SITE INSPECTION SHEET

ADDRESS: 14840 BUSHY PARK RD
410-489-4723

PROPOSAL: REPLACE MENT WELL - OUT OF WATER

PERMIT

LOCATION DIAGRAM

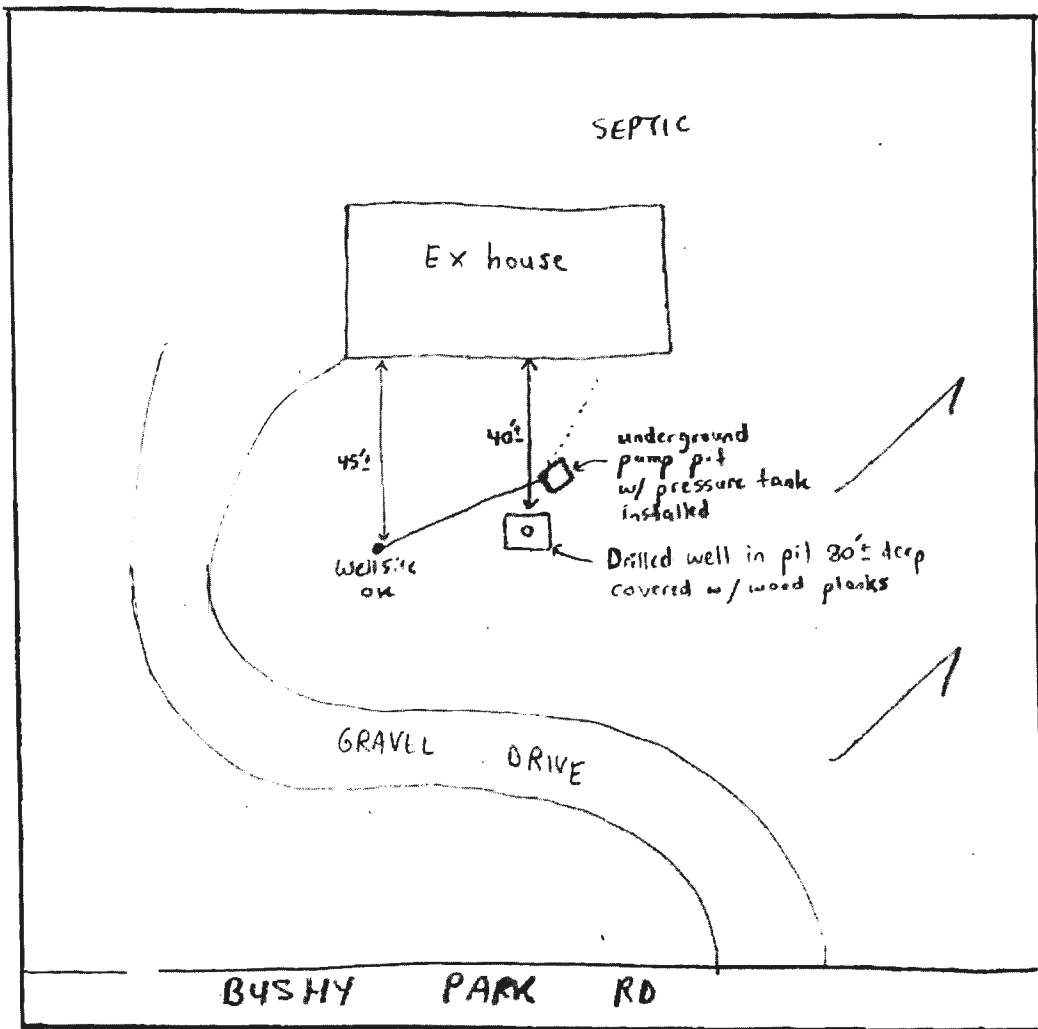
COMMENTS: Existing Drilled Well in pit going dry, to be kept as standby.
New well site OK (SRK)

Built 1975 No Sub Room for 3 replacements

PERMIT CARD

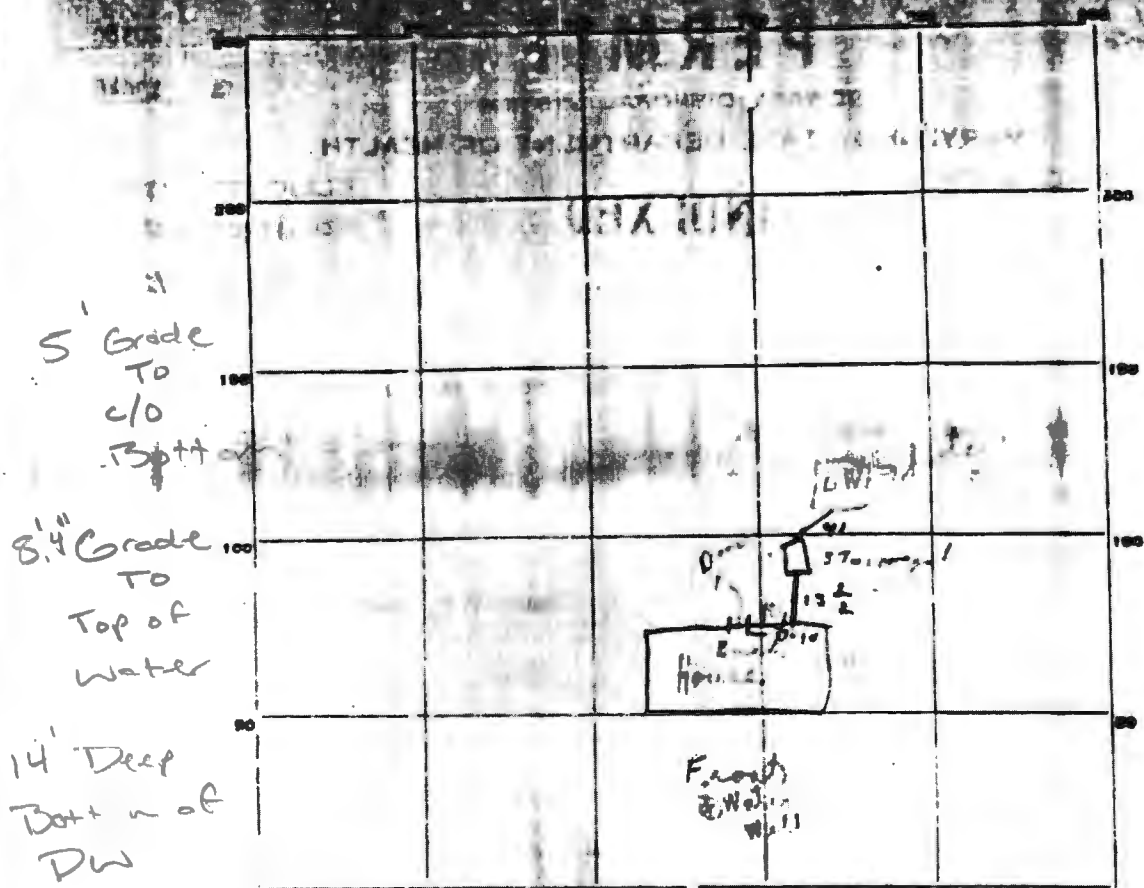
REMARKS
 1/29/74 ① New tank in place ② in place
 (3) P. (4) S. (5) S. (6) S.
 4-1-74 CBS
 10/23/74 - on soil in pipe has been removed.
 ③ in galvanized pipe at 10' - 12'
 ④ connect down to DW. RM

DATE SYSTEM APPROVED 10/23/74 INSPECTOR R. W. Marshall
